# Access Compliance Report

## Public Rights-of-Way

Intersection ID: 43353	Main Street: PROSPERITY RIDGE RD	Cross Street: PROSPERITY COMMONS DR	Location: E
ADA ID: 7A9E84D2B7B5	Ramp Type: PerpDiag	Initial Pass/Fail: Fail	Overall Compliance: No
		Severity Score: 10

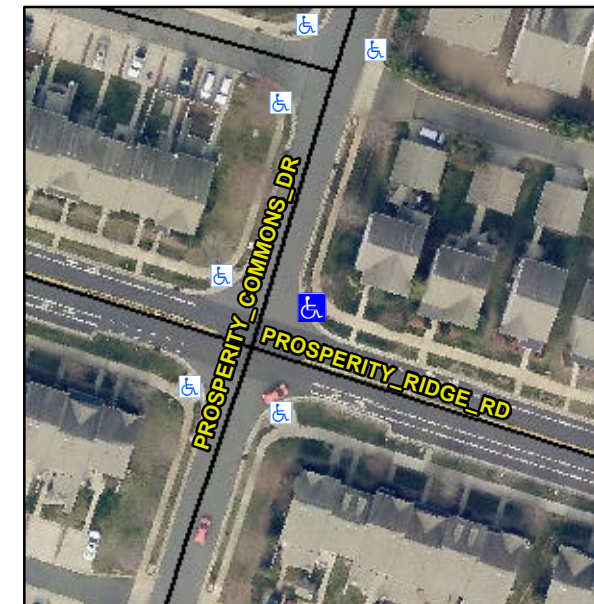
**R304.5.1, R304.5.3**

Compliance	Description	Data	Compliance	Description	Data
N/A	Ramp Length (in)	65.0	Yes	Ramp Slope (%)	7.6
No	Ramp Width (in)	40.0	No	Ramp XSlope (%)	2.6
N/A	Flare Type LT	N/A	N/A	Flare Type RT	N/A
N/A	Flare Slope LT (%)	N/A	N/A	Flare Slope RT (%)	N/A
N/A	Flare Traversable LT?	N/A	N/A	Flare Traversable RT?	N/A
N/A	Landing Length (in)	N/A	N/A	DWS Provided?	N/A
N/A	Landing Width (in)	N/A	N/A	DWS Contrast?	N/A
N/A	Landing Slope (%)	N/A	N/A	DWS Length (in)	N/A
N/A	Landing X Slope (%)	N/A	N/A	DWS Full Width?	N/A
N/A	Landing Curb? (Y/N)	N/A	N/A	DWS Offset (in)	N/A
N/A	Shared Landing?	N/A			
N/A	Gutter Ponding?	N/A	N/A	Gutter Slope (%)	N/A
N/A	Gutter Lip Ht (in)	N/A	N/A	Gutter X Slope (%)	N/A
N/A	Painted X Walk1?	No	N/A	Painted X Walk2?	No
	X Walk 1 Direction	To NW		X Walk 2 Direction	To SW
N/A	X Walk 1 Width (in)	N/A	N/A	X Walk 2 Width (in)	N/A
	X Walk 1 Slope (%)	0.8		X Walk 2 Slope (%)	2.2
	X Walk 1 X Slope (%)	2.1		X Walk 2 X Slope (%)	0.6

**Remove & Replace Curb Ramp With Two New Directional Ramps or Equivalent.**
